To: Members, Coos County Planning Board (by bcc)  
cc: Ed Brisson, Atty. Christine Johnston  
From: Tara Bamford, Contract County Planner  
Re: Balsams Ski Area Site Plan Application – Safety  
Date: February 7, 2023

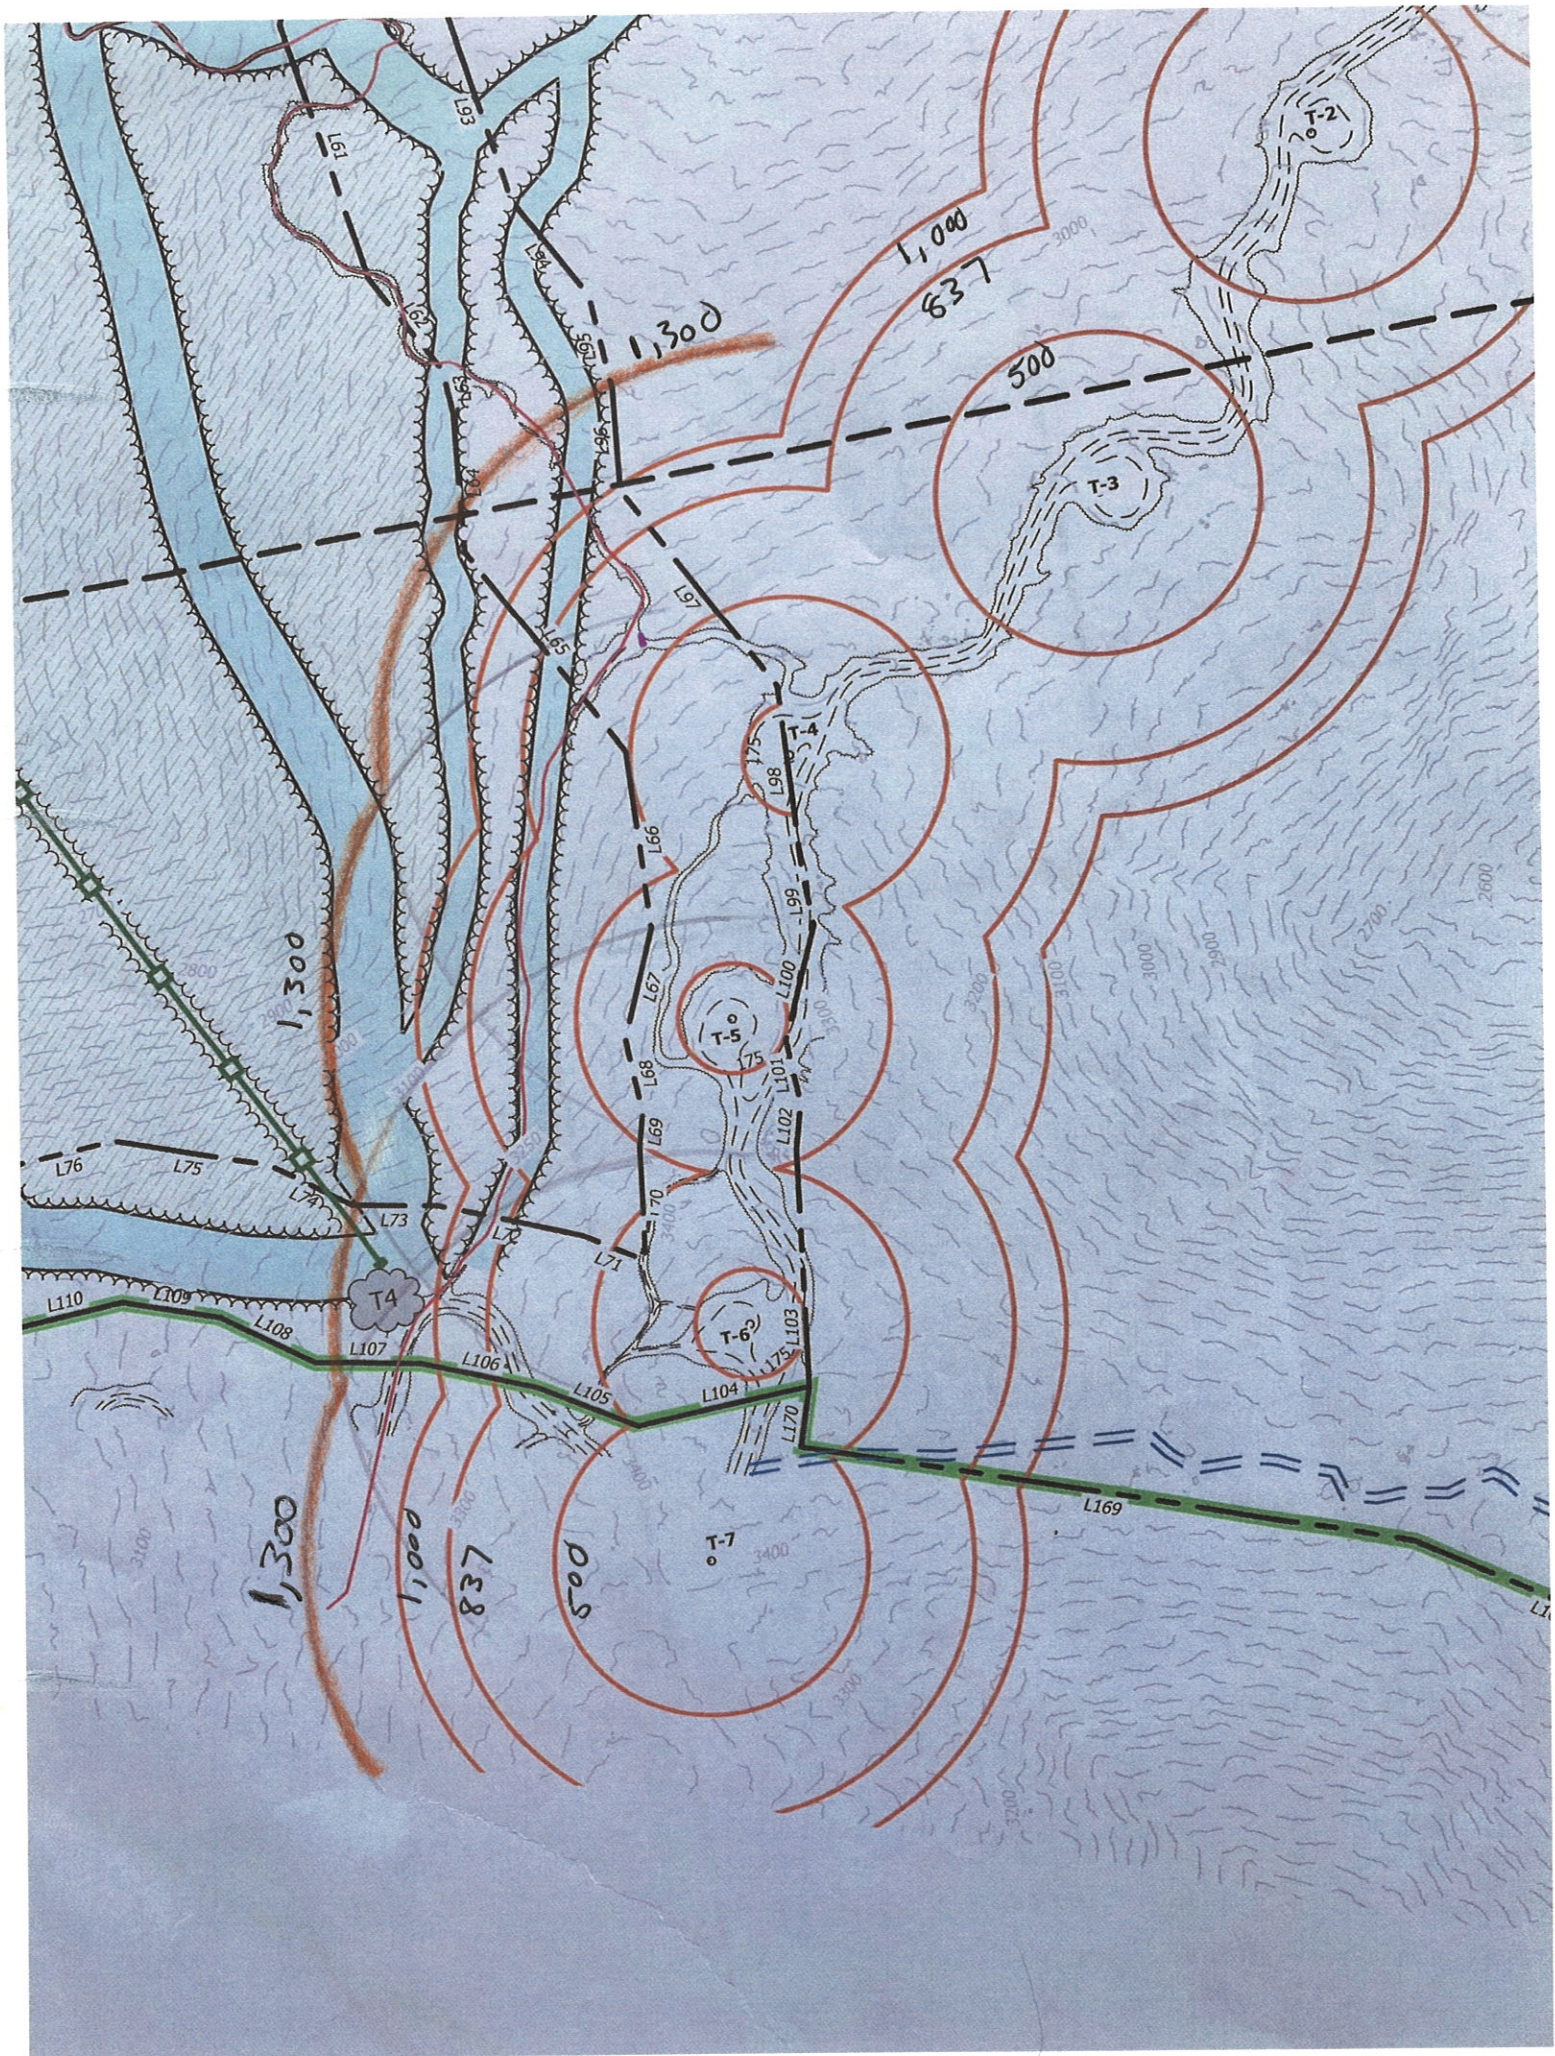
As I noted in my 1/12/23 review comments, while the applicant has been working to develop a safety plan acceptable to the Board regarding potential ice throw by the wind turbines, no information has been provided yet to demonstrate safety from the wind turbines themselves, e.g. rotor fragments in the event of damage or failure. As a reminder, the manufacturer's manual for the Vestas V90 3MW wind turbines (Mechanical Operating and Maintenance Manual, Safety Regulations for Operators and Technicians, 9/11/2006) states: "Do not stay within a radius of 400m (1,300ft) from the turbine unless it is necessary." I've added this 1,300-foot line to the attached for reference.

\*\*\*For a turbine with the height (410 ft) and tip speed (87 m/s) of the Vestas V90-3MW, this model can be used to estimate the distance at which a point has a one in one million chance of being hit by a wind turbine rotor fragment as between 738 feet and 991 feet. For comparison, the applicant's plans show a proposed ski trail just 575 feet from turbine #5.

\*\*\*The 1,300-foot recommendation in the Vestas V90 3MW operators manual is on the very conservative end of that range, about 3.3 times the height. Turbine #1 is approximately 1,175 feet from the top of proposed lifts 10 and 11 (2.87 times the height). The top of proposed lift #4 is about 1,200 feet from turbine #6 (2.93 times the height).

- I recommend that the Board require the applicant to provide documentation regarding the safety of constructing lifts and trails closer than the 1,300-foot setback recommended in the operators manual, a figure accepted by the SEC. This information should include the level of risk from rotor fragments at various locations based on either a peer-reviewed published model or a model published by a government agency.
